DRAWN BY: O.E. WATTS DATE: 6-13-19 DWG. NO.: 19-5341-03 TOPOGRAPHY BY: CITY FMS 6-12-19 SURVEY INFORMATION BY: RAMPART JOB NO. 18384	APPROVED BY: _____ PROJ. NO.: _____ DWG.: _____	REVISIONS 8-16-21 UPDATED OEW 12-30-21 REVISED PER COUNTY REVIEW COMMENTS OEW 8-22-22 REVISED PER COUNTY REVIEW COMMENTS OEW	OLIVER E. WATTS CONSULTING ENGINEER COLORADO SPRINGS	PROJECT: ROCKY TOP MOTEL & CAMPGROUND PART NW1/4 SECTION 9, T.13S., R.68W., 6TH P.M. EL PASO COUNTY	SHIT. NAME: GRADING AND EROSION CONTROL PLAN	SHIT. NO.: 1 OF 4
--	---	--	--	---	--	-------------------

# Grading & Erosion Control Plan\_V3.pdf Markup Summary

## Glenn Reese - EPC Stormwater (31)

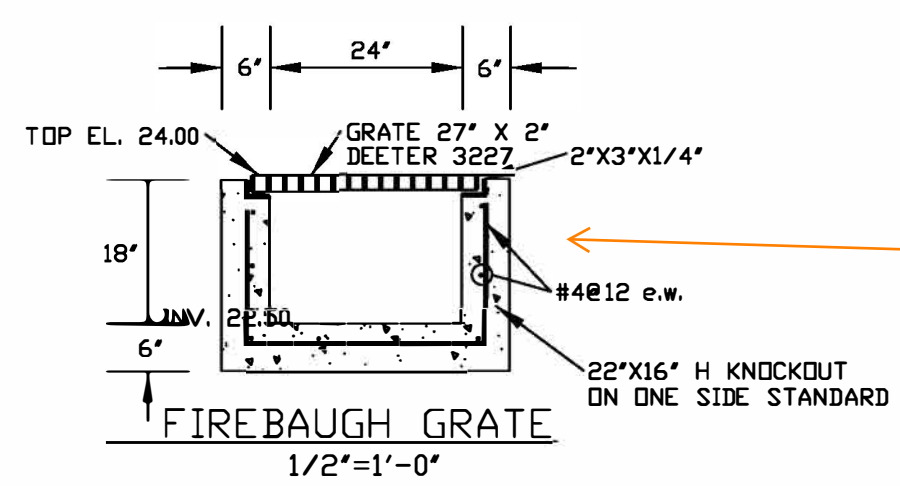
As previously stated: this VTC will need to be within the LOD. But honestly, since this VTC would only be used for the RV area disturbance (0.144ac) and none of the other 4 areas of disturbance, it'd probably be best/easiest to just not have a VTC at all and just implement/encourage street sweeping and shoveling. Having a VTC for such a small area does not make sense. Plus the surrounding gravel areas will act as mini-VTCs.

GEC Checklist Items H and M. If "limits of disturbance" and "construction boundary" are the same, change to "limits of construction/disturbance" or otherwise show as separate line types for each on the legend and figure.

Page 3 of the PBMP Applicability Form shows LOD as 1.104ac. Revise to remove discrepancies.

Show location of newly added runoff reduction (RR) area. The RR area is discussed in the Drainage Report text and calculations were provided but the limits of that area are not delineated anywhere.

- GEC Checklist Item "i" - add a note about existing vegetation.
- GEC Checklist Item "o" - identify areas of cut and fill.

GEC Checklist Item "o" - callout as office grading

Grading doesn't show swale terminating at an LP here... Maybe best to provide a detail that shows "bowl" shape fine grading around inlet.

Grading doesn't show swale terminating at an LP here... Maybe best to provide a detail that shows "bowl" shape fine grading around inlet.

proposed grading outside of LOD and not connected to an existing contour.

Is there still going to be SF here? Linetype was remove but bubble remains.

Unresolved comment from previous review: inlet piping still not shown and label invert.

Unresolved comment from Review #2 and #3: SP's and SSA's should be within the LOD.

Per DCMv2 Section 4.3, outlet pipe should be 18" minimum. (UD Figure 6-a)

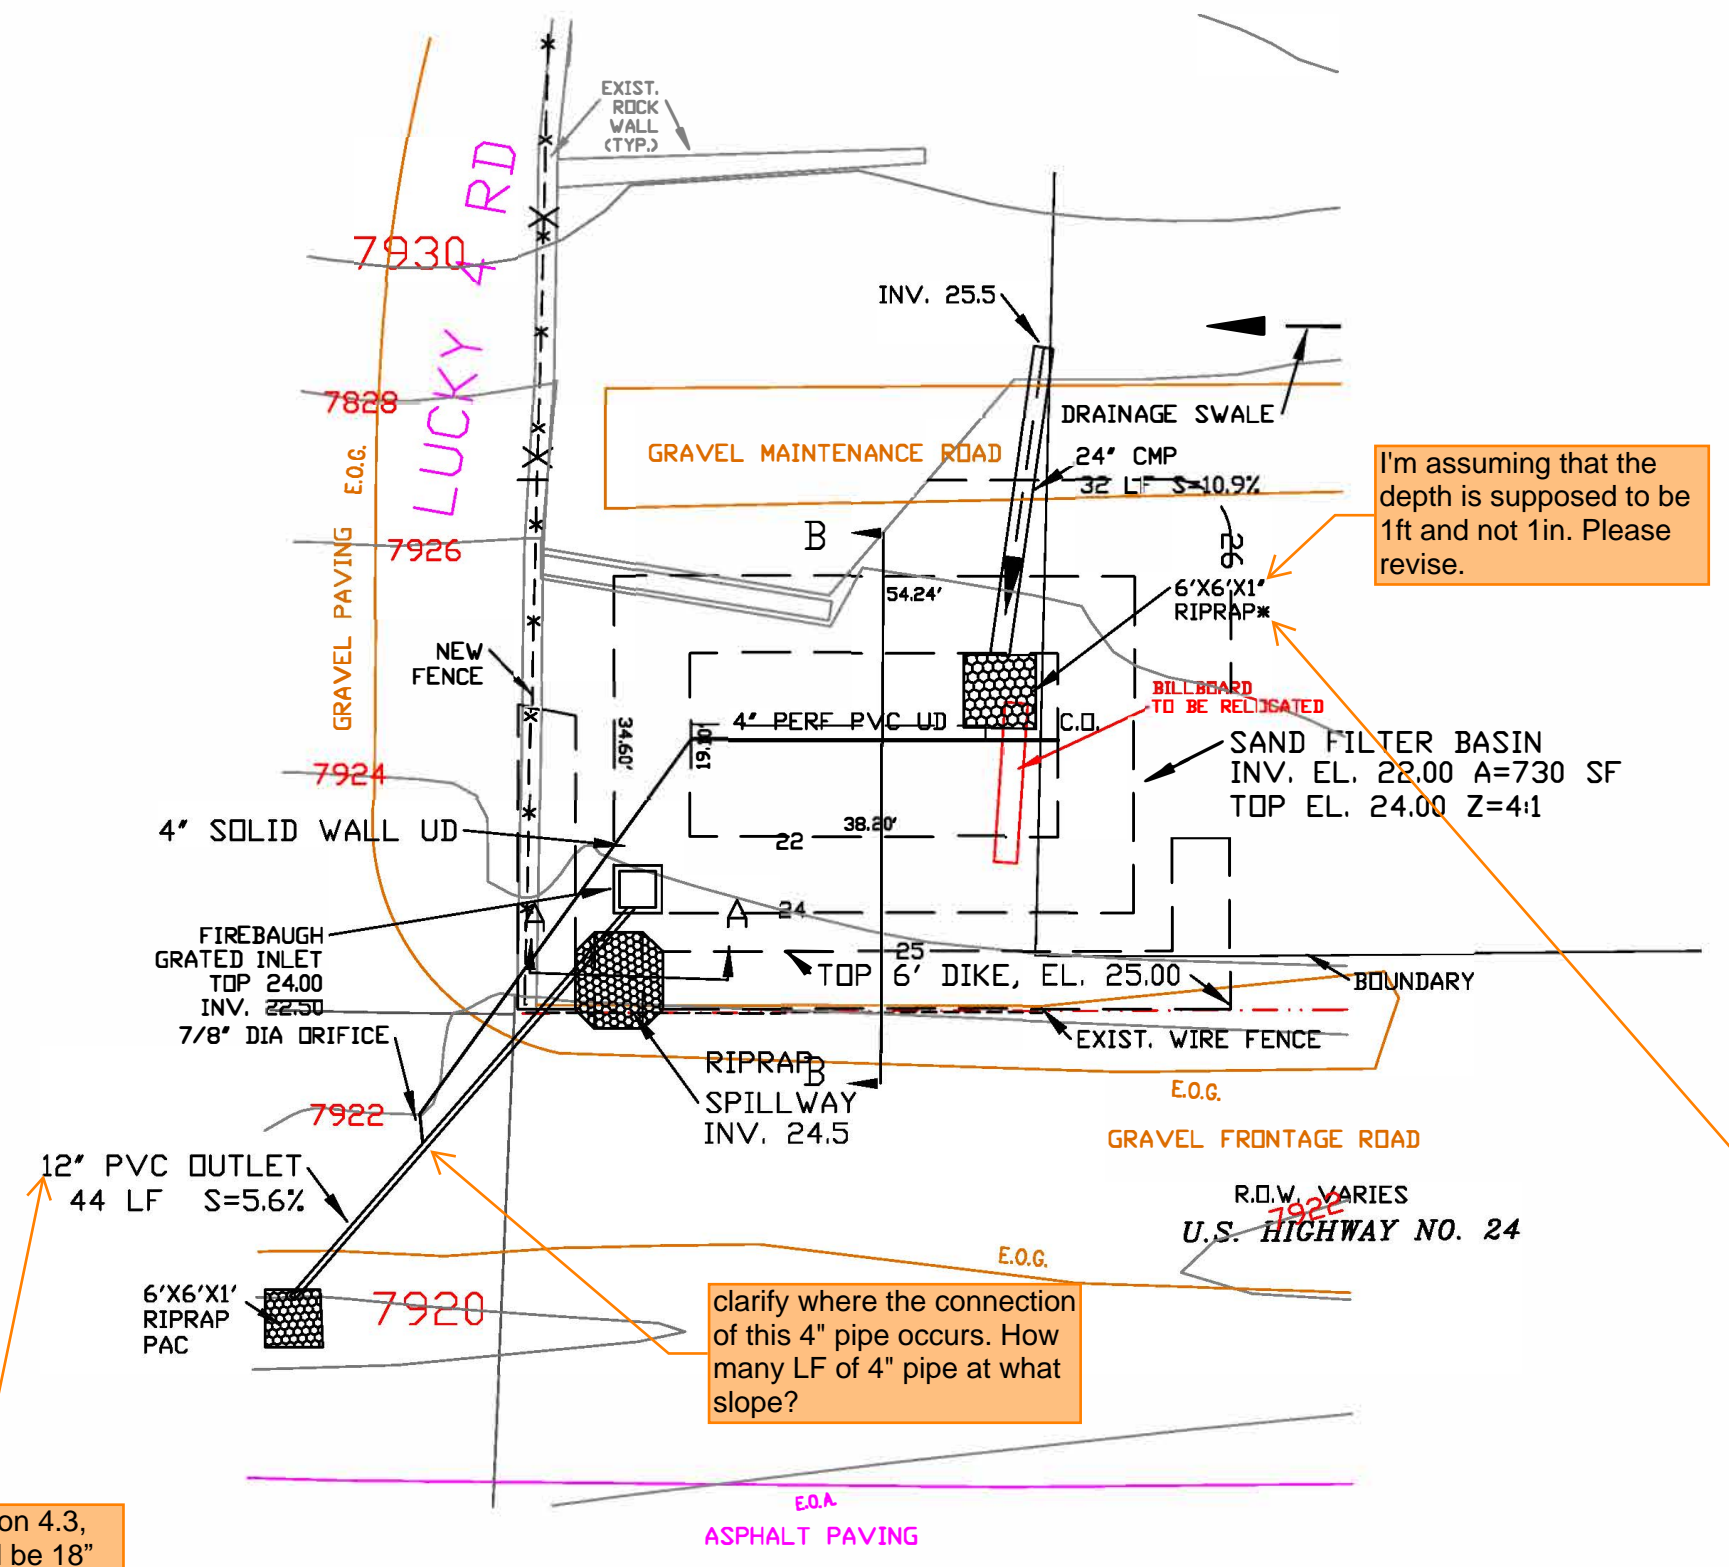
show outlet pipe connection

I'm assuming that the depth is supposed to be 1ft and not 1in. Please revise.

clarify where the connection of this 4" pipe occurs. How many LF of 4" pipe at what slope?

Per DCMv2 Section 4.3, outlet pipe should be 18" minimum. (UD Figure 6-a)

This type of soil riprap with topsoil is fine for the spillway but is not appropriate for the erosion protection at the bottom of the SFB where the inlet pipe outfalls. We don't want to encourage the growth of vegetation with the topsoil nor do we want to introduce more sediment into the SFB which will cause extra maintenance. So create a separate asterisk or text callout for these locations.

WEST SFB DETAILS  
1"=20'

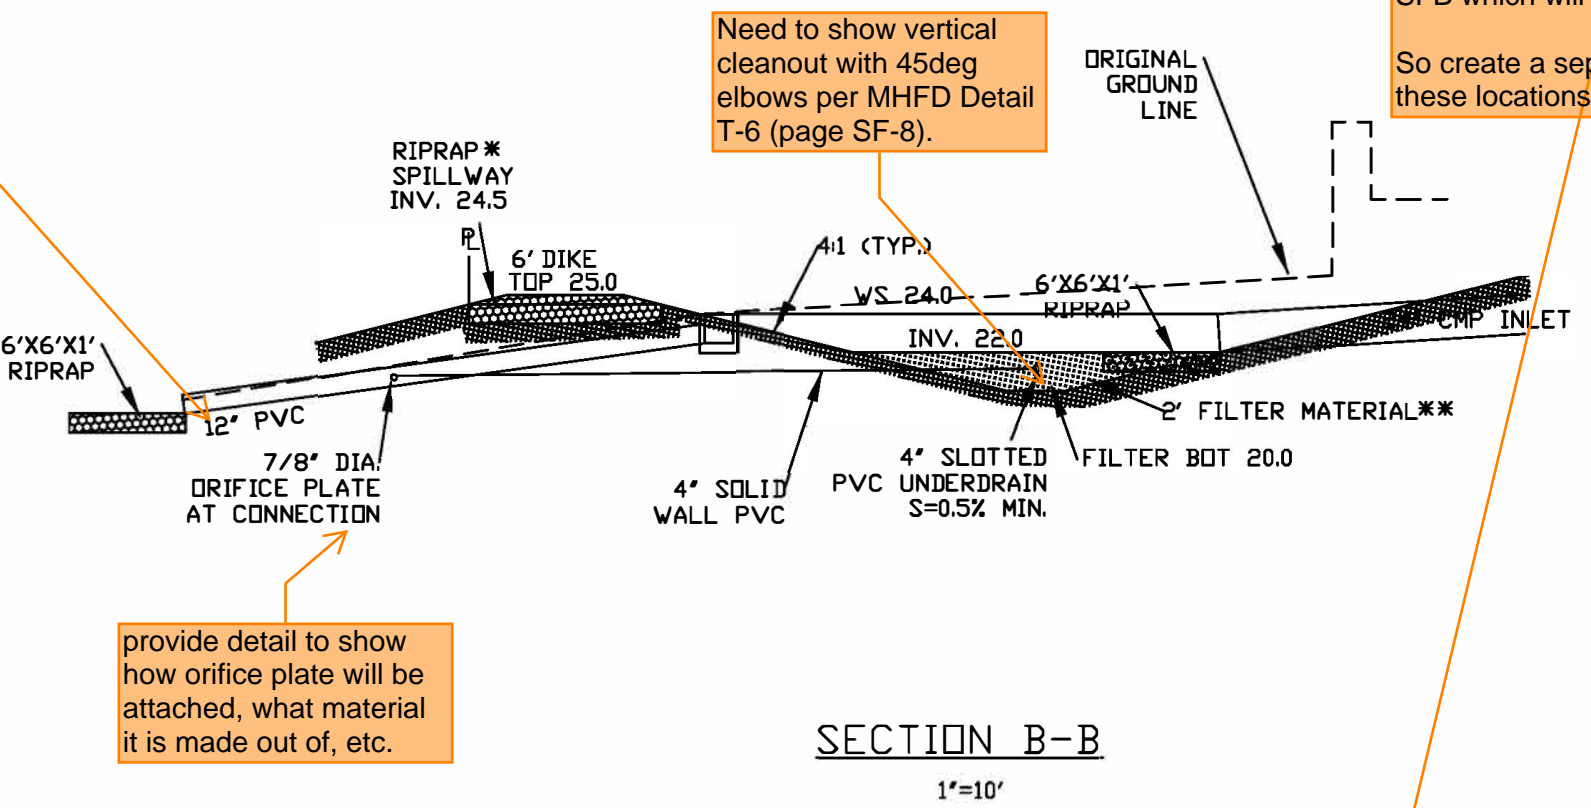
provide detail to show how orifice plate will be attached, what material it is made out of, etc.

EAST SFB DETAILS  
1"=20'

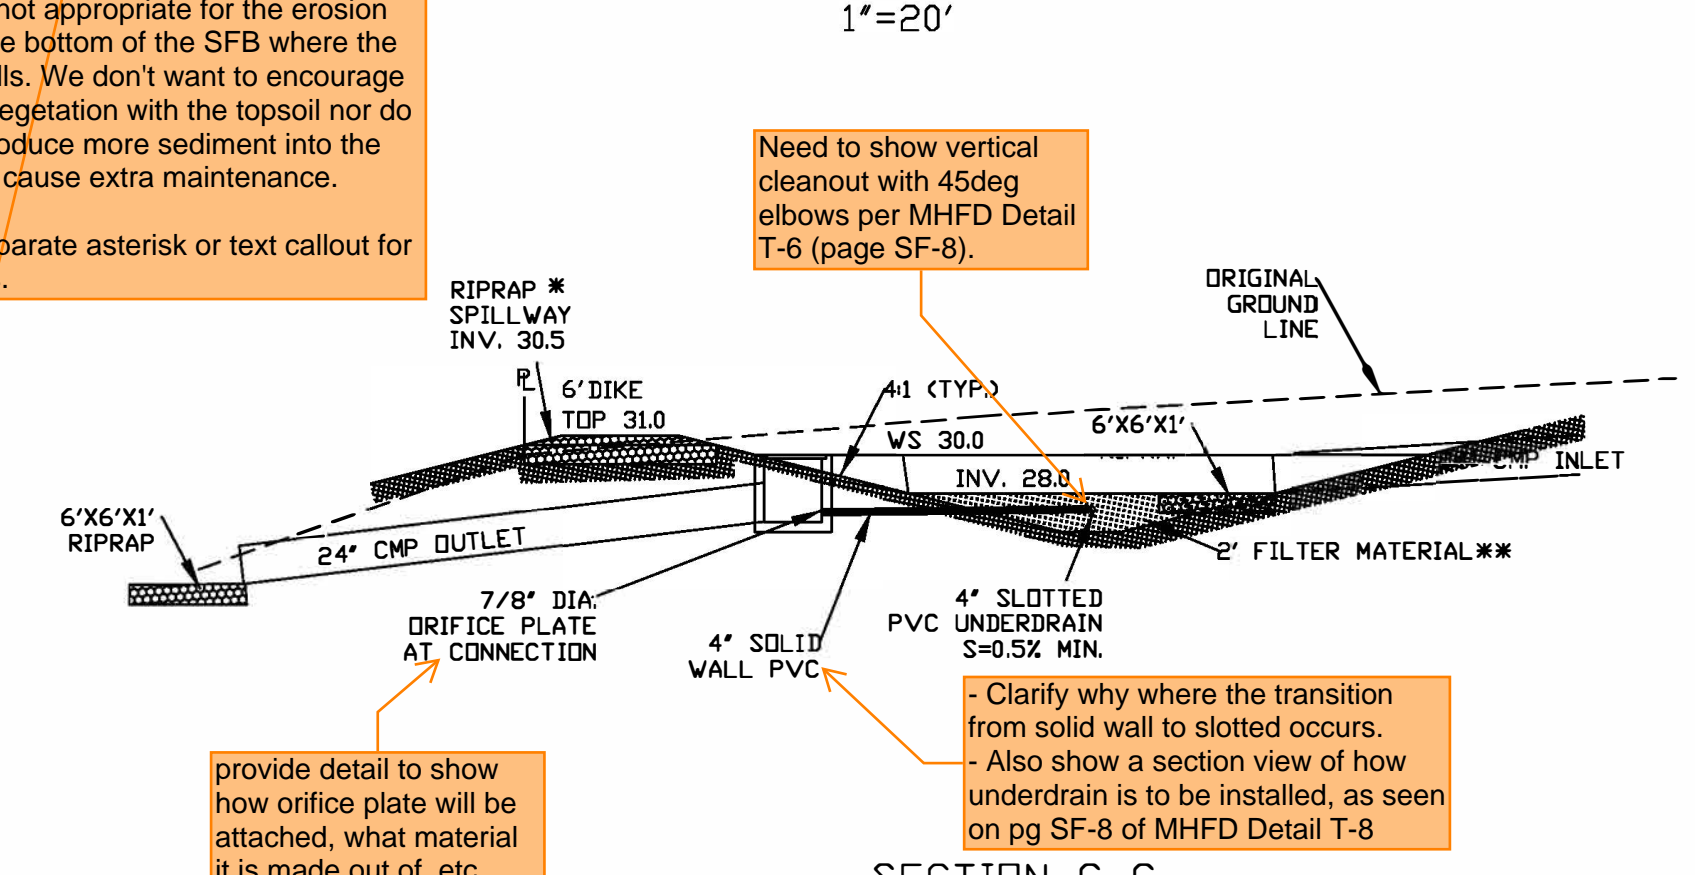
Need to show vertical cleanout with 45deg elbows per MHFD Detail T-6 (page SF-8).

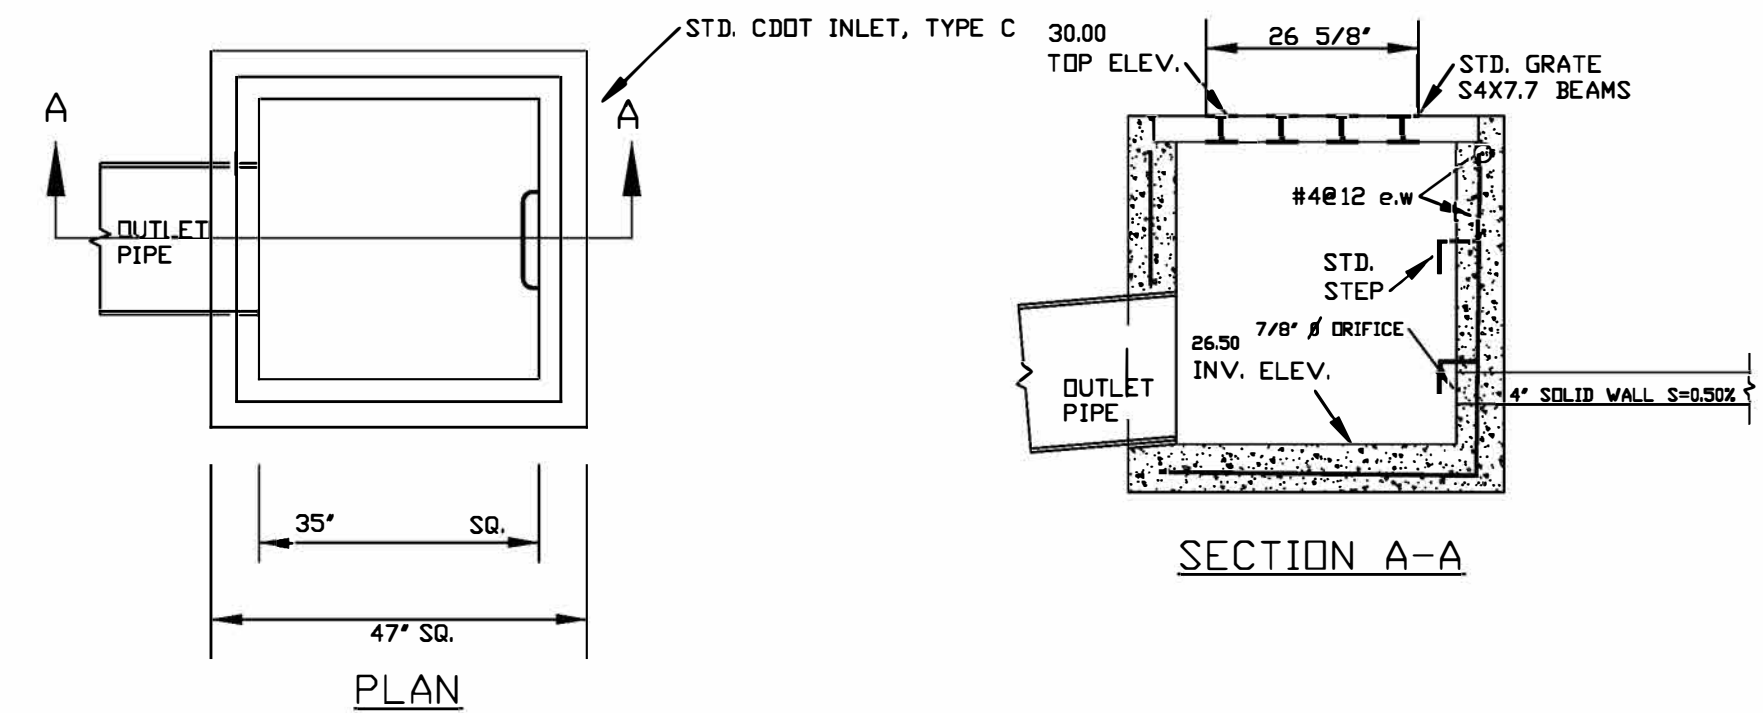
provide detail to show how orifice plate will be attached, what material it is made out of, etc.

Clarify why where the transition from solid wall to slotted occurs. Also show a section view of how underdrain is to be installed, as seen on pg SF-8 of MHFD Detail T-8

Please review MHD Detail T-6. SFB bottoms are to remain unvegetated. Side slopes should be vegetated.
